**TOWN OF NEWBURGH
PLANNING BOARD
TECHNICAL REVIEW COMMENTS**

PROJECT: MEADOW HILL ROAD EXPANSION
PROJECT NO.: 2016-07
PROJECT LOCATION: SECTION 60, BLOCK 1, LOT 9.1 & 9.2
REVIEW DATE: 27 MAY 2016
MEETING DATE: 2 JUNE 2016
PROJECT REPRESENTATIVE: JMC ENGINEERING

RE: JMC Project 16015
 Meadow Hill Expansion
 Meadow Hill Road
 Town of Newburgh, NY

SITE GRADING PLAN
 MEADOW HILL ROAD EXPANSION
 TOWN OF NEWBURGH, NY

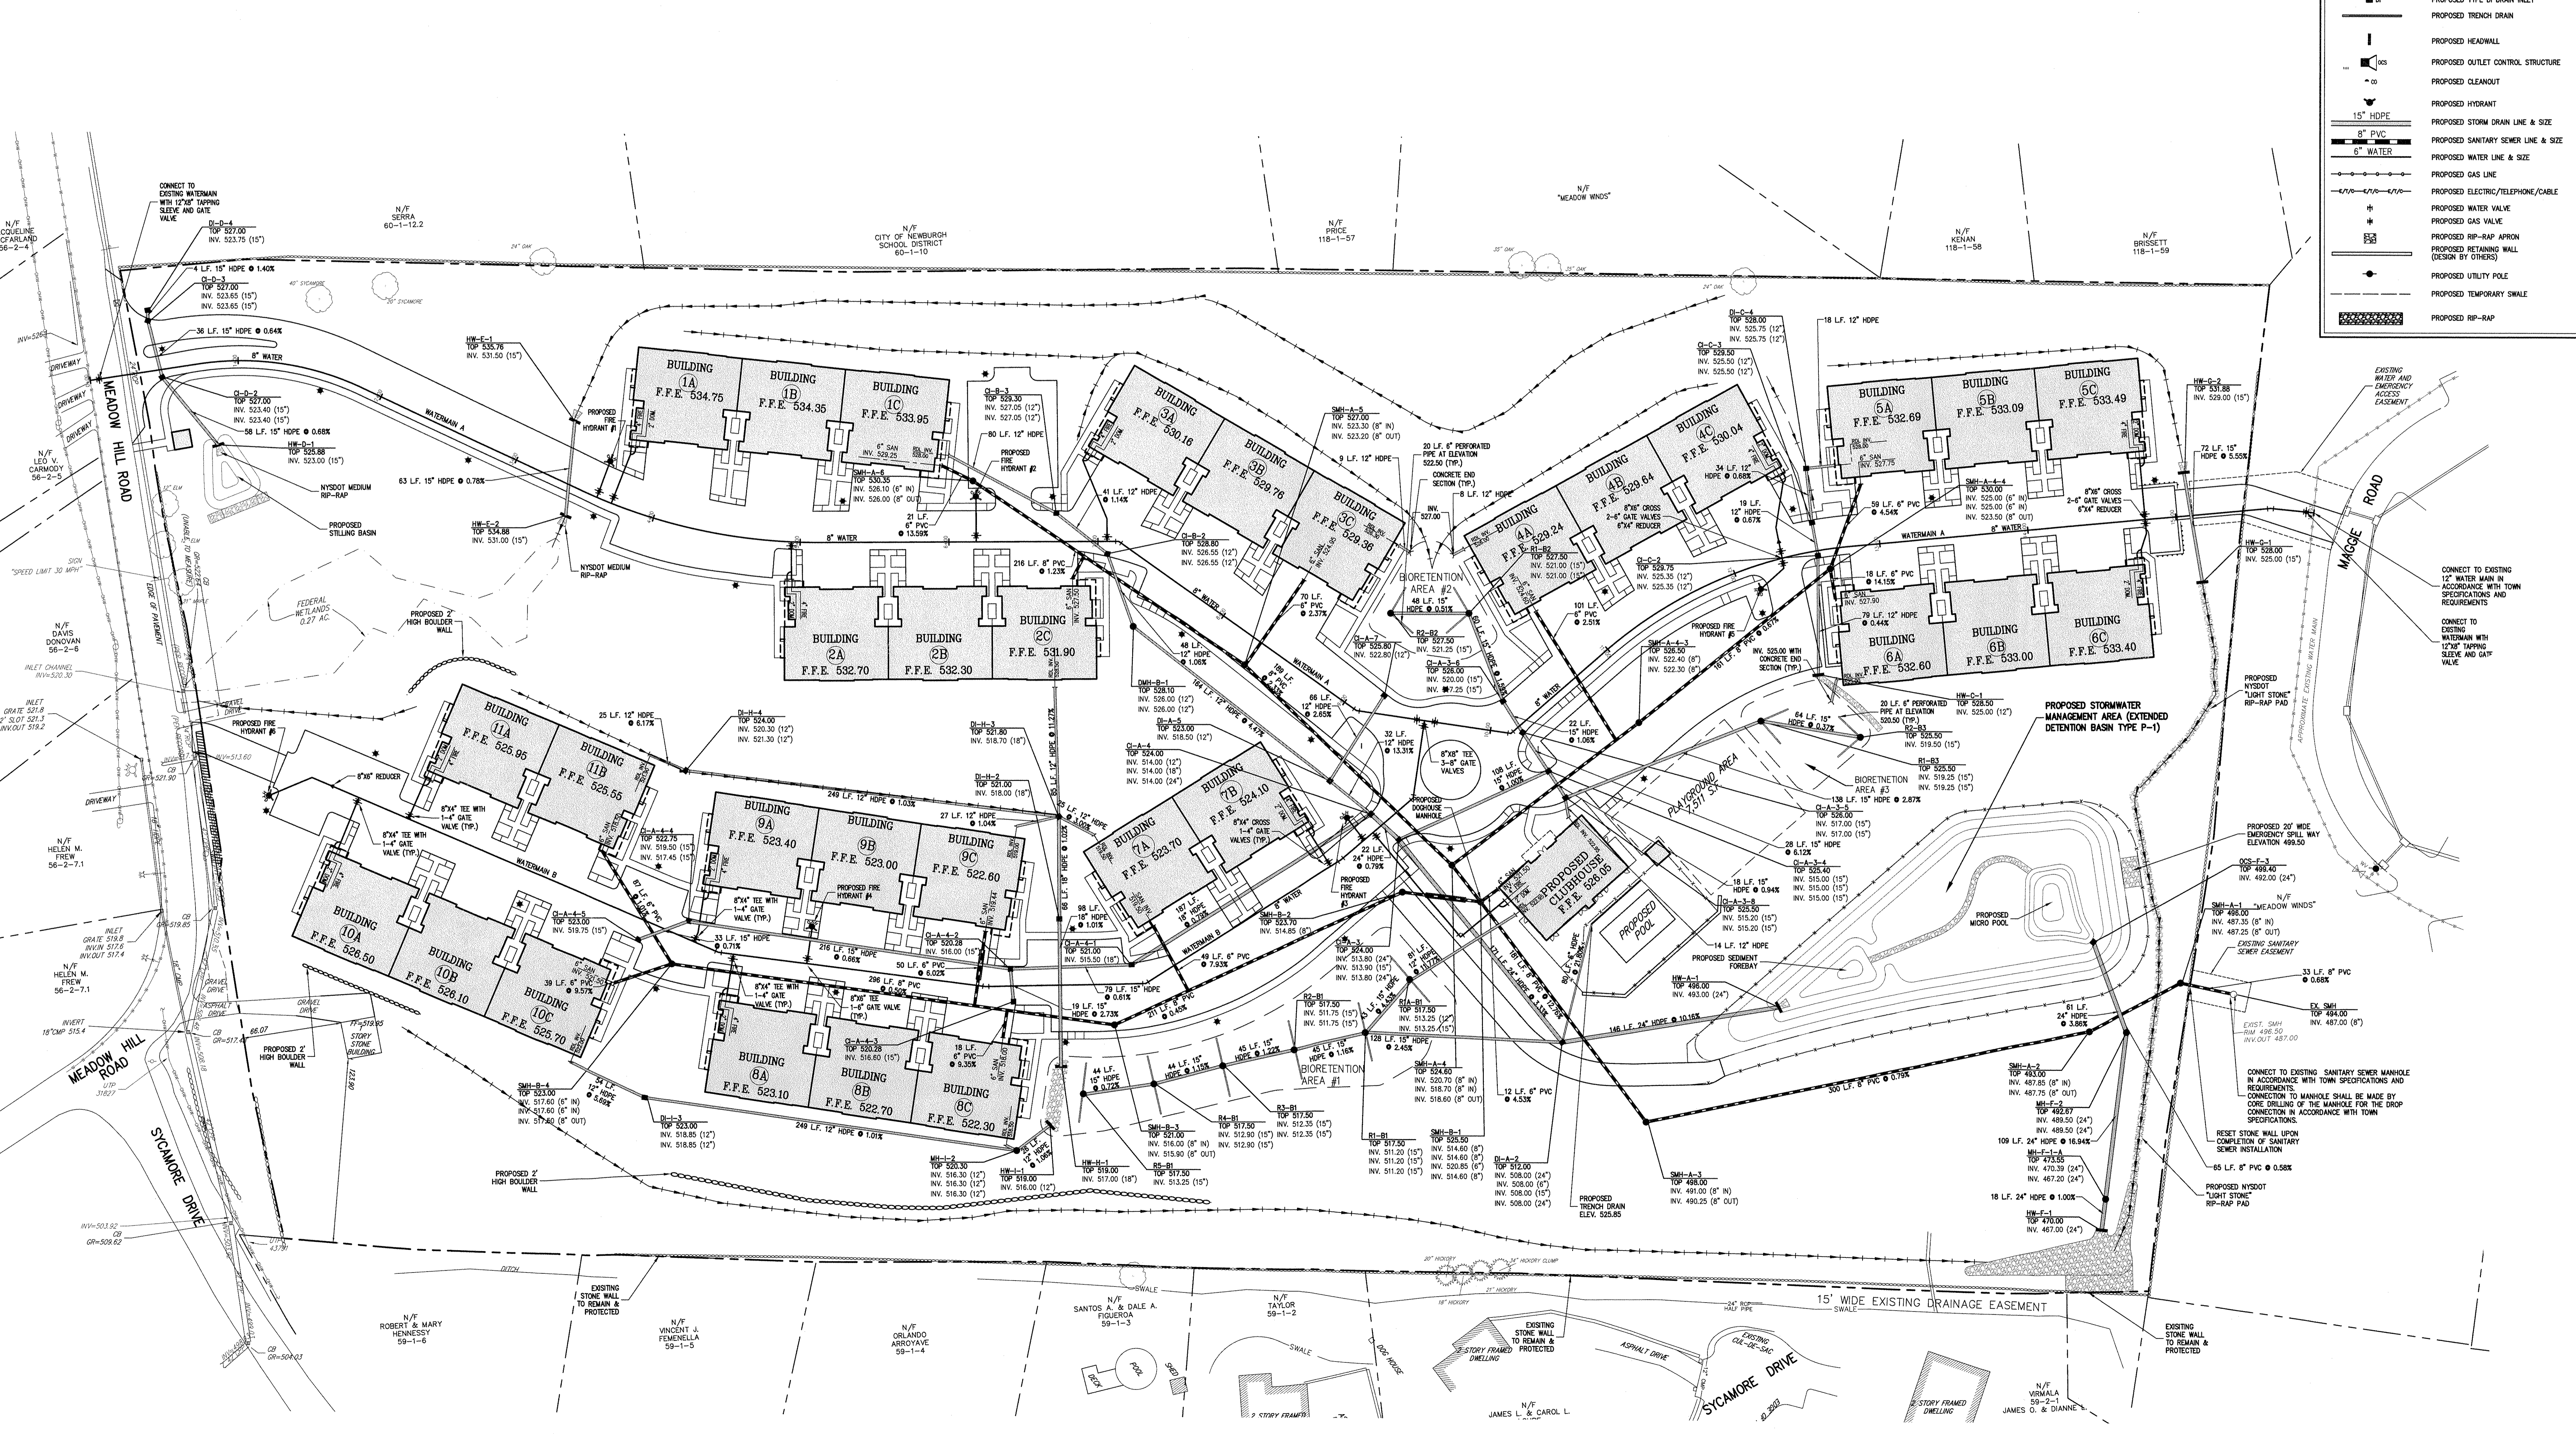
Proposed grading has extended grading along the easterly property line to the rear of parcels fronting on Sycamore Drive. The Applicant's Engineer has requested to evaluate relocation of the swale along the

easterly property line in a westerly direction toward the toe of the proposed slope to provide additional non disturbed area to the rear of the Sycamore parcel.

The JMC drawing SP-5 "Grading Plan" and has been revised to relocate the proposed drainage swale allows proposed grading slope.

SITE UTILITIES PLAN
 MEADOW HILL ROAD EXPANSION
 TOWN OF NEWBURGH, NY

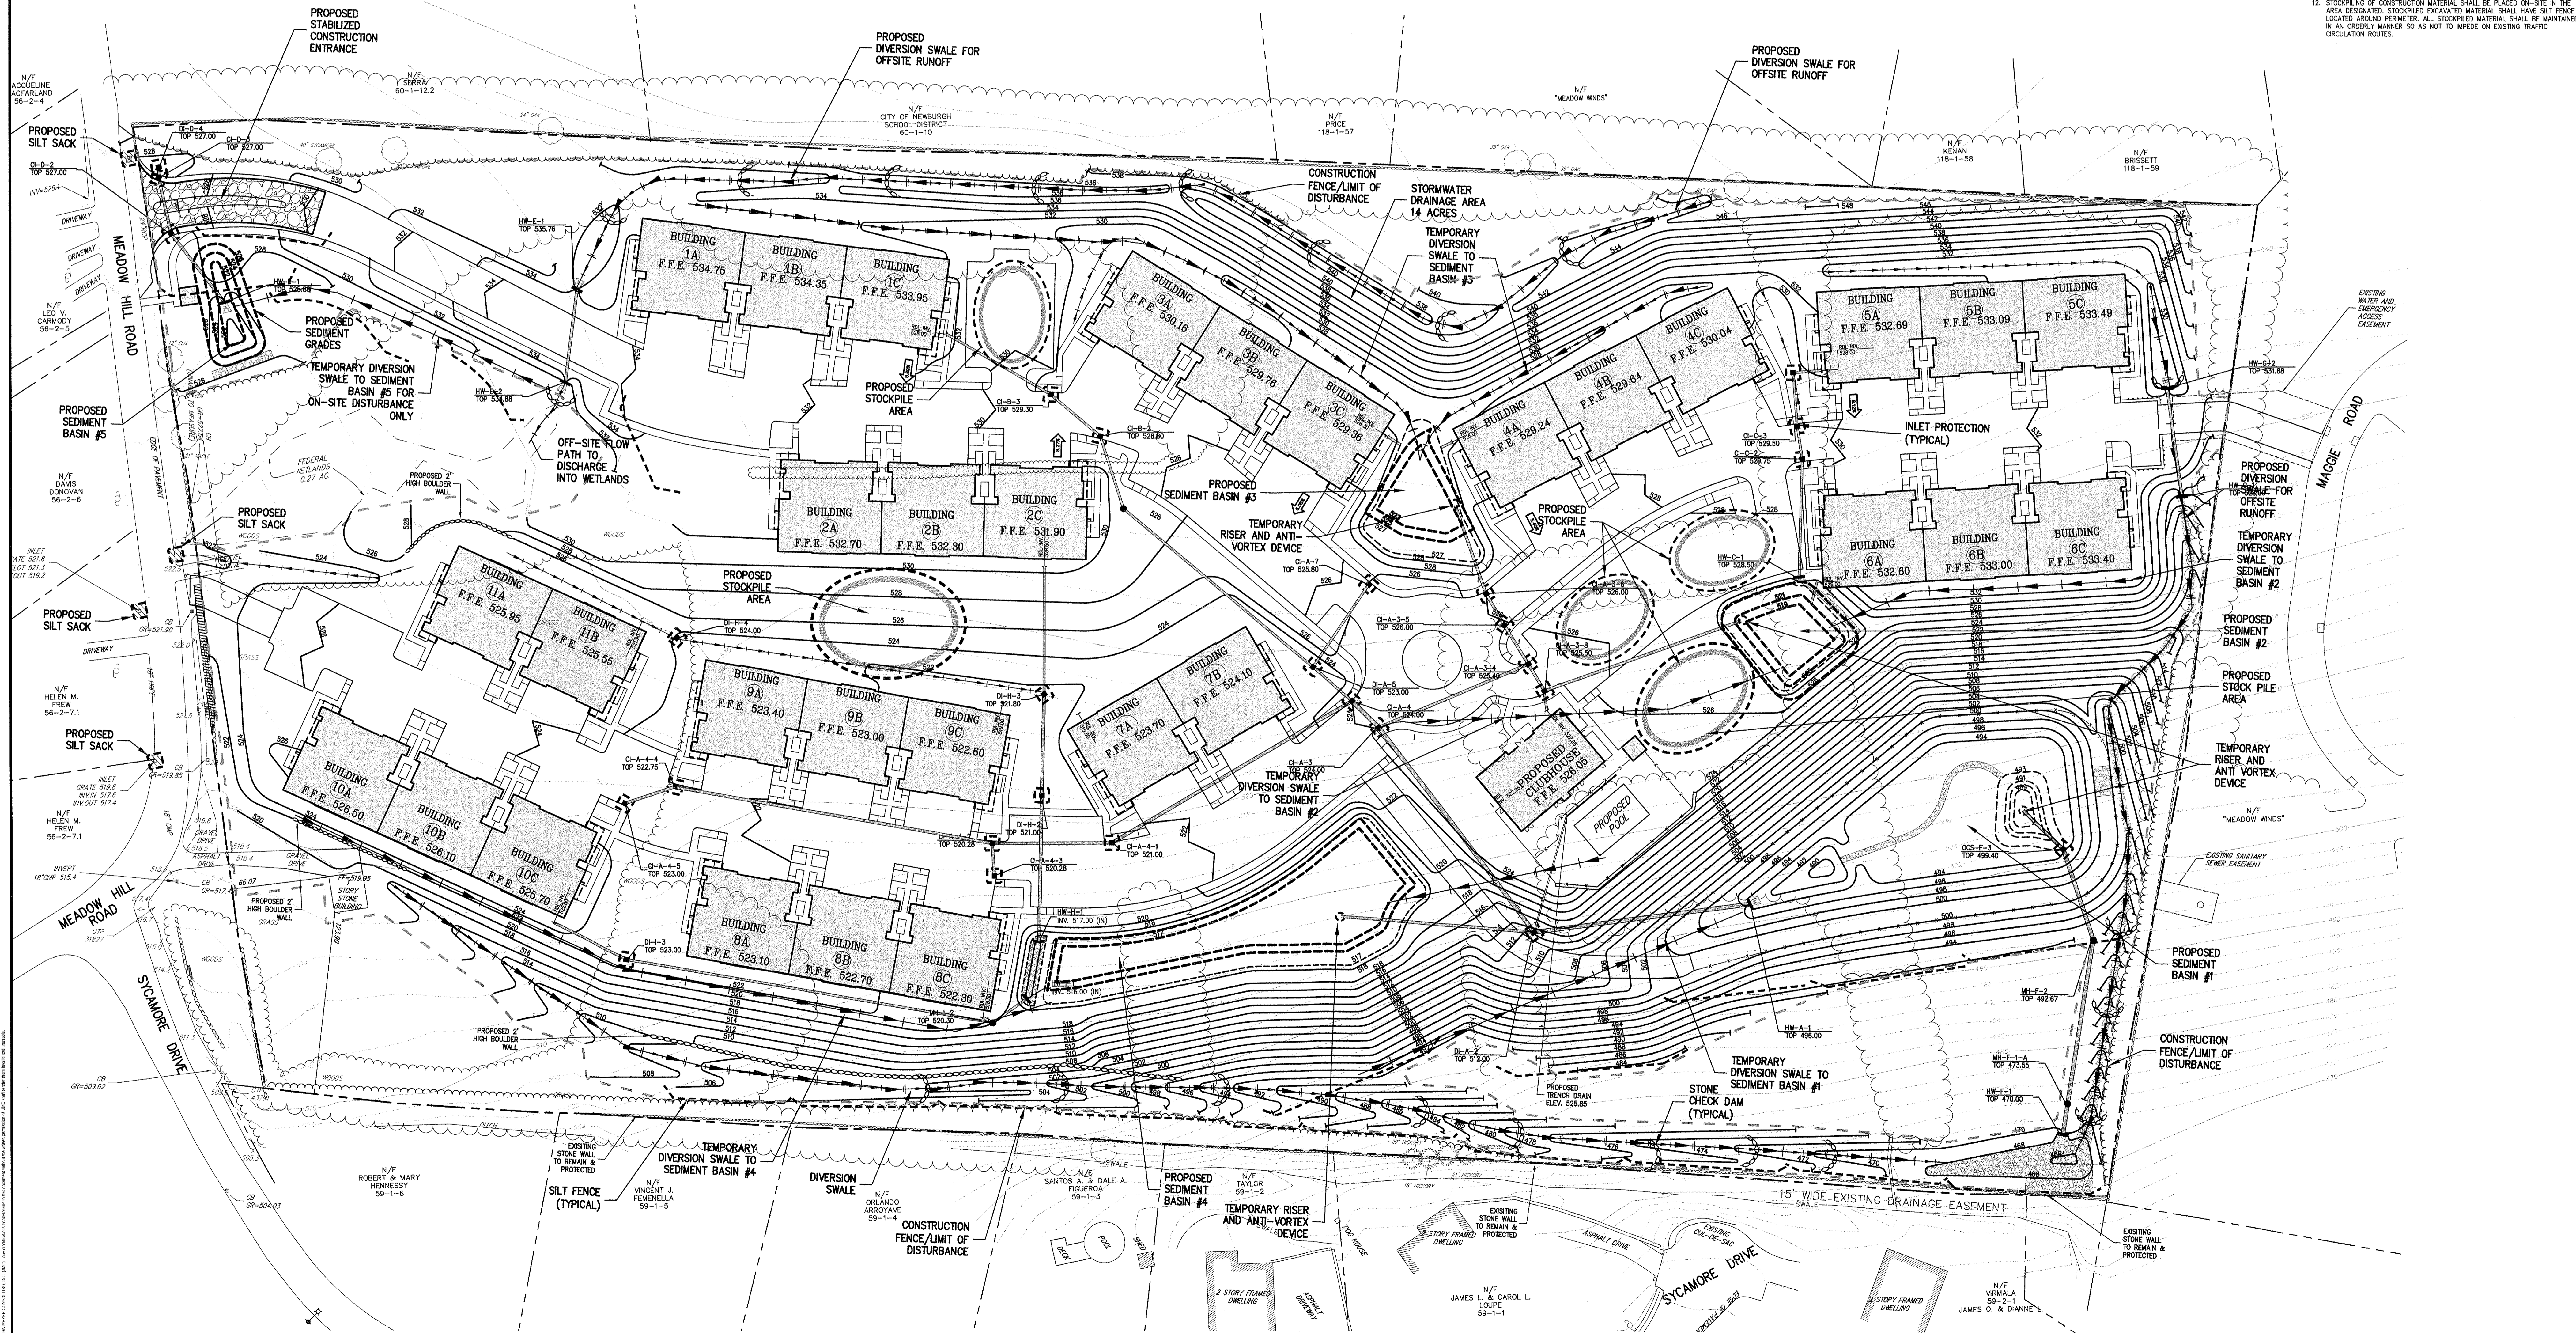
The Applicant's representative are requested to evaluate a required extension to the storm drain system currently terminating to the north of buildings 8 & 9. Flow from the south end of buildings 10 & 11 will be conveyed across access roads for an extended distance.

The JMC Drawing SP-6 has been revised to include two additional structures adjacent to buildings 10 and 11.
